# United States Patent and Trademark Office

This is the **Final Office Action** for application number 10/755,524 Vent Cover Bracket and Process Therewith filed on 1/12/04. Claims 1-4, 8-15 and 17-24 are pending. This **Final Office Action** is in response to applicant's reply dated 2/27/06. The text of those sections of Title 35, U.S. Code not included in this action can be found in a prior Office action.

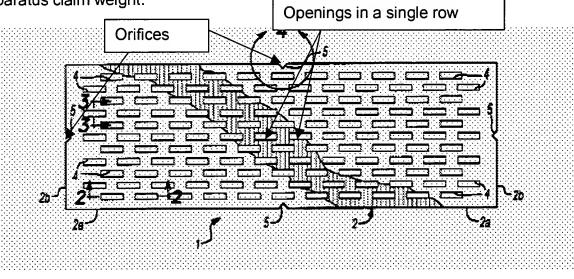
The patent to Ward teaches a rectangular plate (1), having front and back faces, and a length and a width, and opposing edges (2a, 2b) extending in respective length and width directions, at least two openings (4, See Drawing Below) in the plate (1), each opening (4) which are completely through the plate and wholly contained within the front and back faces so as to not intersect with the side edges and wherein the at least two openings (4) comprise a single row and are slots and the slots have a length extending parallel to the length direction of the plate and the slots are each located on a center axis of the plate relative to the length direction of the plate and at least one pair of

orifices which are notches (5) associated with each slot and having a length extending parallel to the width of the plate and are located adjacent opposite side edges, and opposite sides of at least one of the two openings (4) and midway between opposite ends of the opening, and which extend completely through and intersect the side edges of the plate along the length of the plate, the notches extending into the plate toward the center axis of the plate relative to the length direction, wherein the notches do not intersect the adjacent opposite side edges and do not intersect at least one of the slots and intersect at least one of the slots, wherein the notches form a weakened zone associated with each slot which is perpendicular to the length direction. Ward also discloses that the orifices (5) can be four in number and wherein each pair of orifices is located on opposite sides of the openings and midway between opposite ends of the one opening and a second pair of orifices is located on opposite sides of a different opening of the two openings and midway between a first end of the first opening and a second end of a different opening. Note, the process steps were not given structural or apparatus claim weight.

The applicant has argued that the Ward reference does not teach a single row of slots and wherein one pair of orifices are associated with each slot. This is unpersuasive in that the Ward reference teaches single rows of slots which are side by side as shown above. Further, there are a pair of orifices which are associated with each slot, one on the end and one on each side of the rectangular plate, clearly indicated in the marked drawing above.
